Generic design assessment UK EPR nuclear power plant design by AREVA NP SAS and Electricité de France SA

**Assessment report
Gaseous radioactive waste
disposal and limits**

Assessment report – gaseous radioactive waste disposal and limits

PCERsc6.4s3 Figure 1

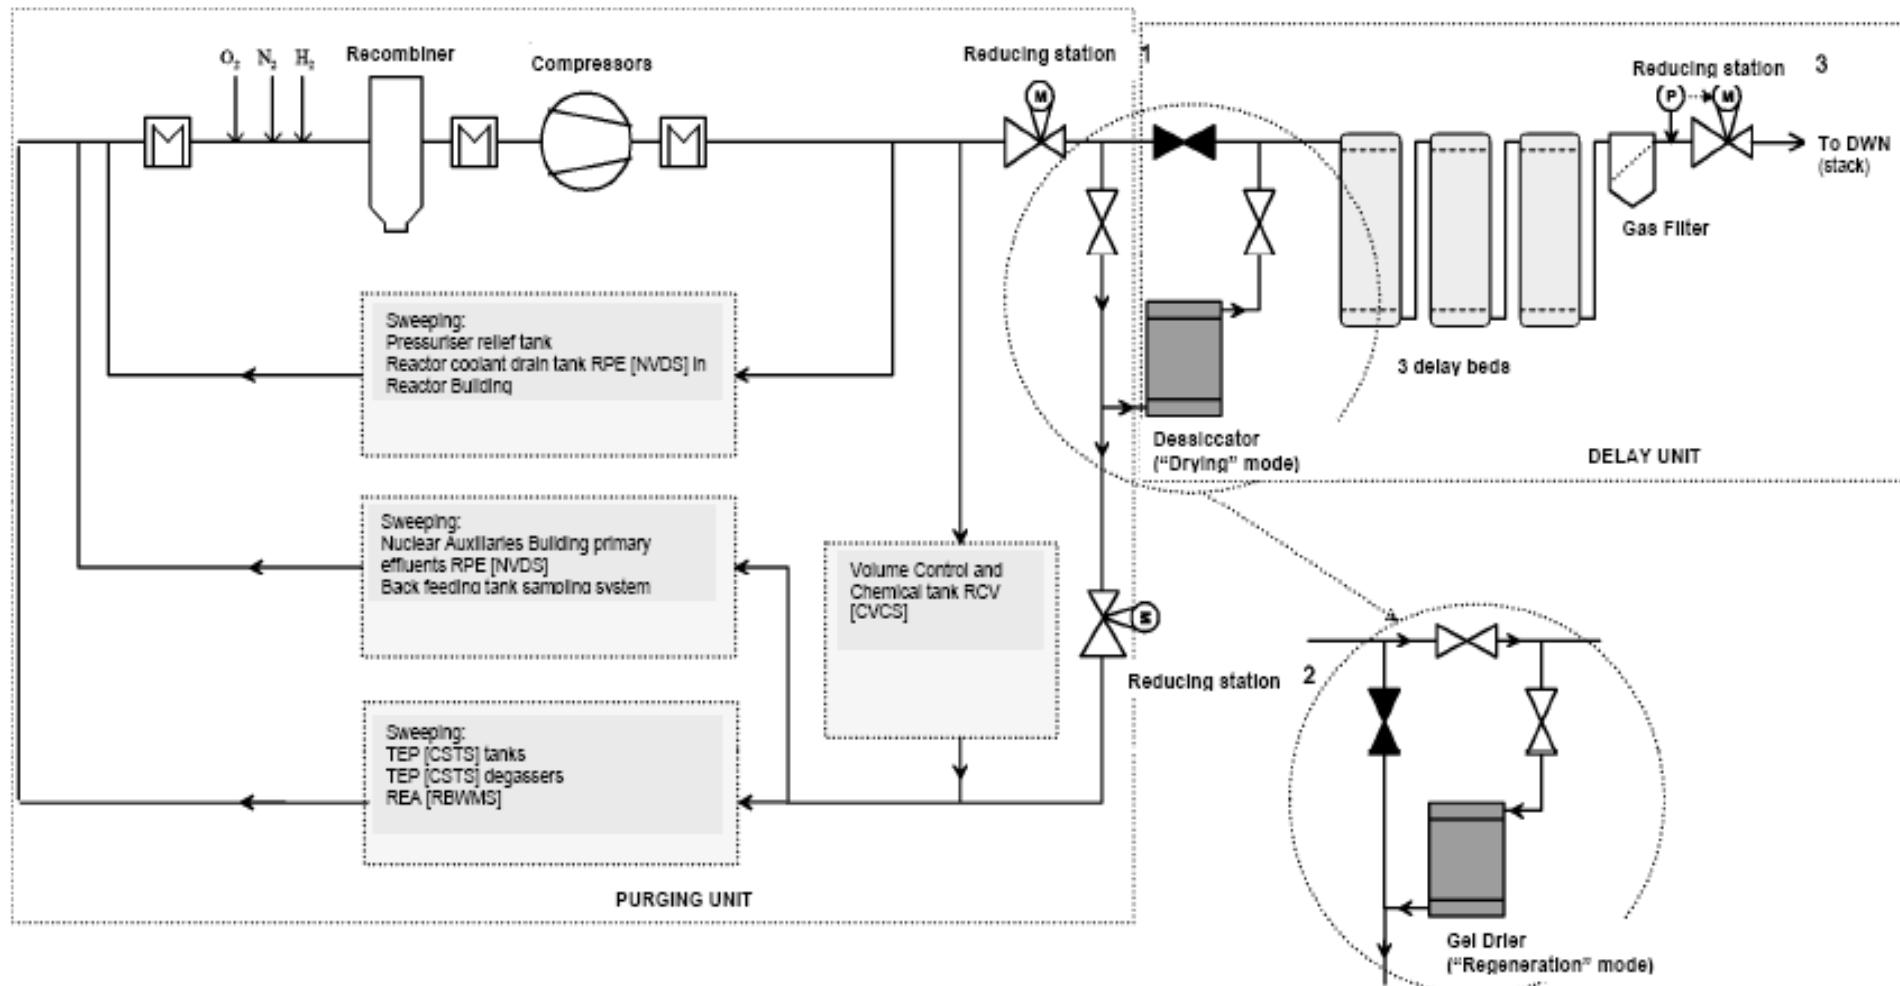
- ii) The degasification system is served by the purge system but is not used in normal operation. It is usually used to treat coolant at shut-down and its waste gases sent through the purge system to the delay system. The degasification system would be used during normal operations in the event of fuel failures leading to excessive levels of dissolved noble gases in the coolant. (PCERsc6.2s1.2.3.1, diagram PCERsc6.4s3 Figure 1 (page 80), reproduced in the Annex to this report)

PCERsc6.2s1.2.3.2 Figure 10

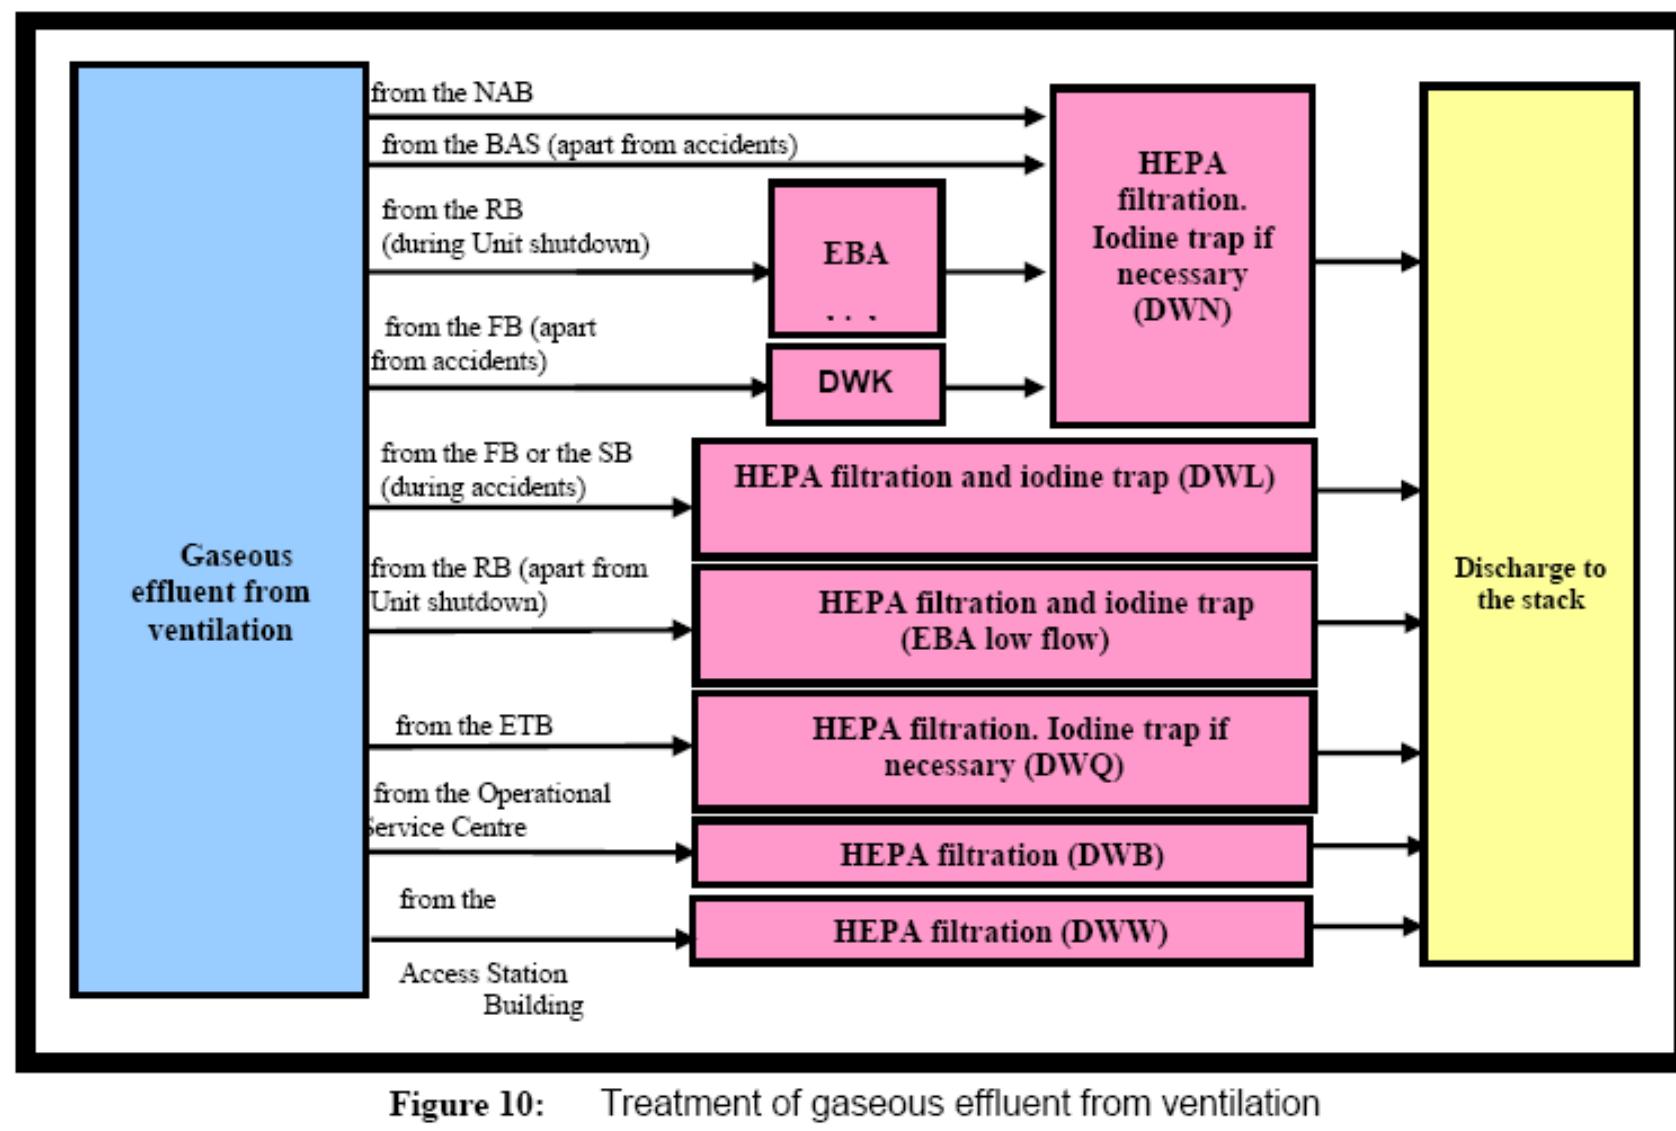
- b) The ventilation of buildings within the UK EPR that may be contaminated with radioactivity, in particular the Nuclear Auxiliary Building and the Fuel Building. Ventilation air that may contain radioactive particulates and gases, in particular iodine radionuclides (I-131 and I-133), is passed through filters and, if iodine detected, iodine traps before discharge. (PCERsc6.2s1.2.3.2 and Figure 10, reproduced in the Annex of this report)

- c) Gaseous effluent from the secondary circuit. This would be mainly air collected in the condenser vacuum system that could be contaminated with radioactivity, particularly tritium, in the event of a tube leak in the steam generators. The collected gases are filtered before discharge, the pathway from the NAB (Nuclear Auxiliary Building) is shown in PCERsc6.2s1.2.3.2 Figure 10 (reproduced in the Annex of this report).

PCERsc6.3s7.4.3.1 Figure 16

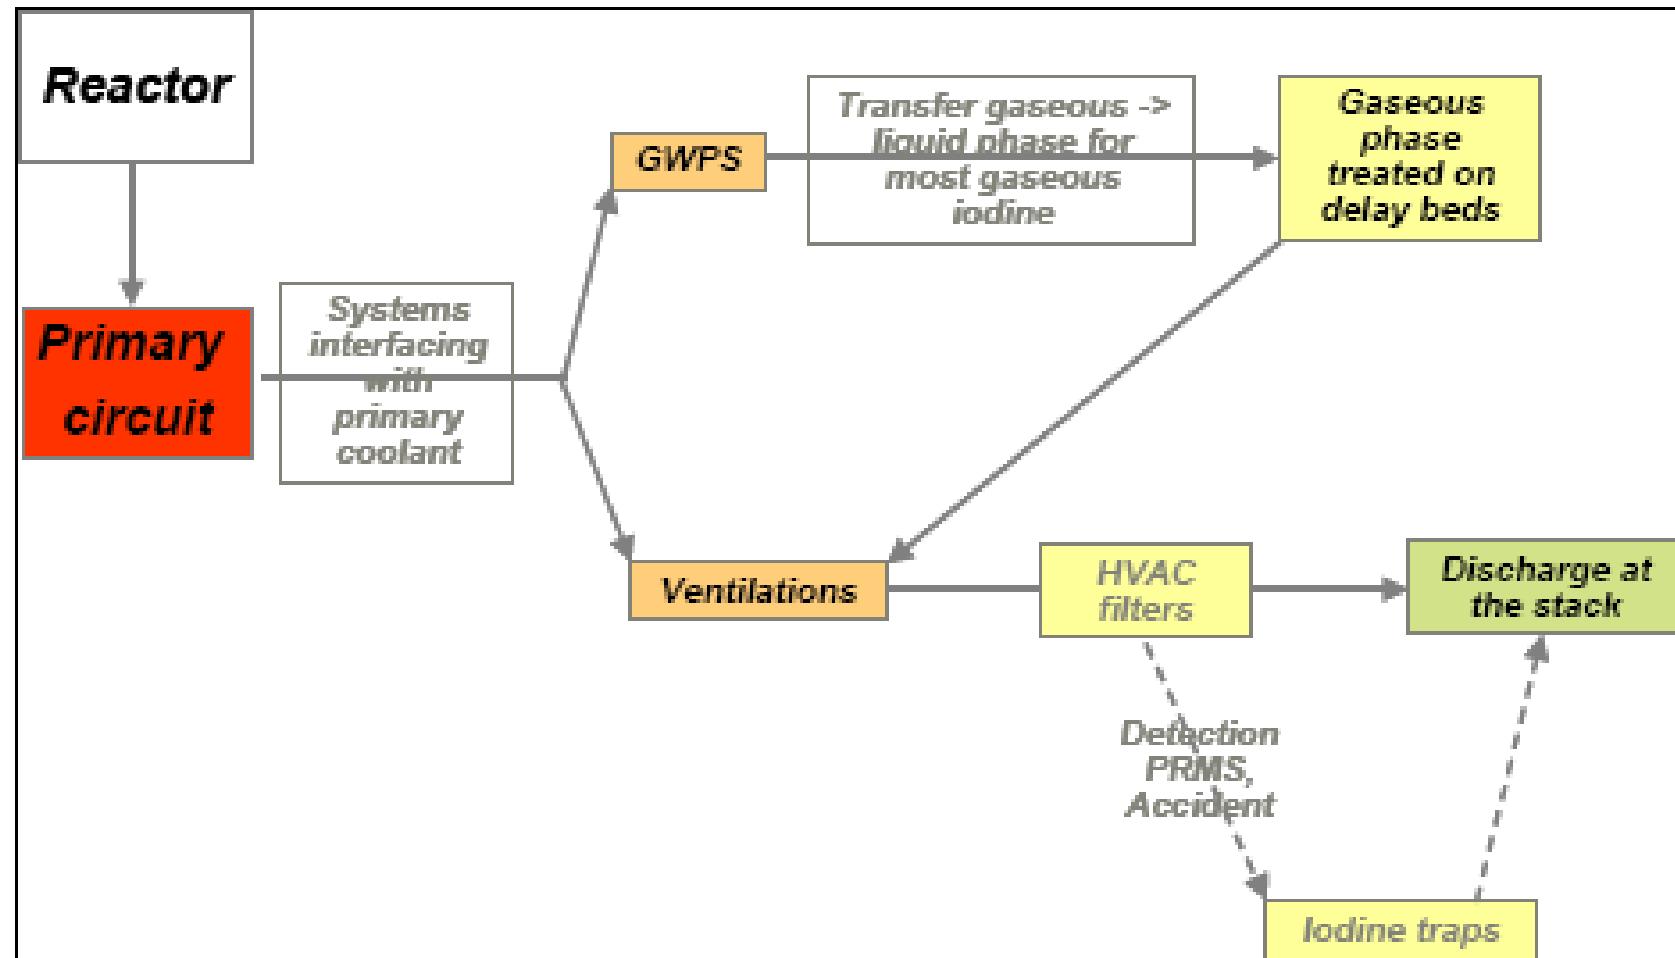
96 Any iodine radionuclides coming from leaks in the primary coolant circuit will enter the ventilation systems. These systems will send ventilation air to activated charcoal iodine traps if high iodine radioactivity is detected or as a precaution during certain operations or in case of accidents. (PCERsc6.3s7.4.3.1 Figure 16, reproduced in the Annex of this report).
